Saltstone Disposal Facility Performance Assessment

DOE Responses and Approaches to Second Round of NRC Requests for Additional Information

April 27, 2010

SRR-CWDA-2011-00081

Figure SP-3.1
Moisture Characteristic Curves for Saltstone
Reflecting Progressive Fracturing in Case K

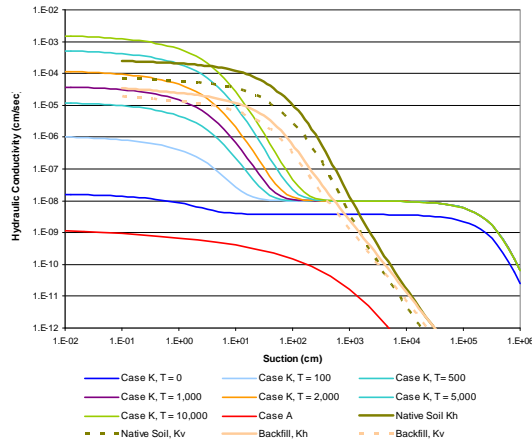
- RAI SP-3
- NRC Comment Summary
 - The moisture characteristic curves (MCCs) for intact saltstone used in the PORFLOW model does not account for experimental uncertainties and is inconsistent with literature values
- DOE Proposed Approach
 - Case K includes MCCs that are more representative of literature values and are incorporated within the progressive fracture model identified in the proposed approach for SP-2
 - Figure SP-3.1 illustrates an example of MCCs reflecting progressive fracturing at the start of various time steps with comparison to the Case A model and soils.

Figure VP-6.1
Moisture Characteristic Curves for Walls
of Vaults 1 and 4 for Case K, Case A, and Soils

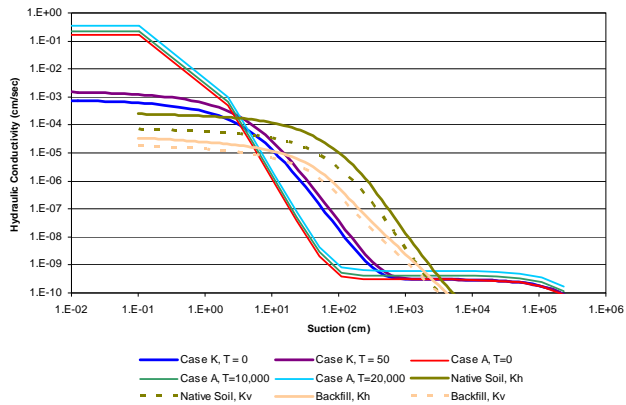
- RAI VP-6
- NRC Comment Summary
 - Provide support for the assumed hydraulic conductivity of the degraded Vaults 1 and 4 walls that result in the modeled bypassing of flow around the saltstone wastefrom
- DOE Proposed Approach
 - The initial hydraulic conductivity of the walls for Vaults 1 and 4 is based on a macroscopic crack model to acknowledge current wall seepage
 - Case K utilizes a different initial cracking spacing that results in a hydraulic conductivity 100 times less than used in the PA. Figure VP-6.1 illustrates the moisture characteristic curves used for the Vault 1 and Vault 4 walls for Case K, the PA Base Case, and soils.
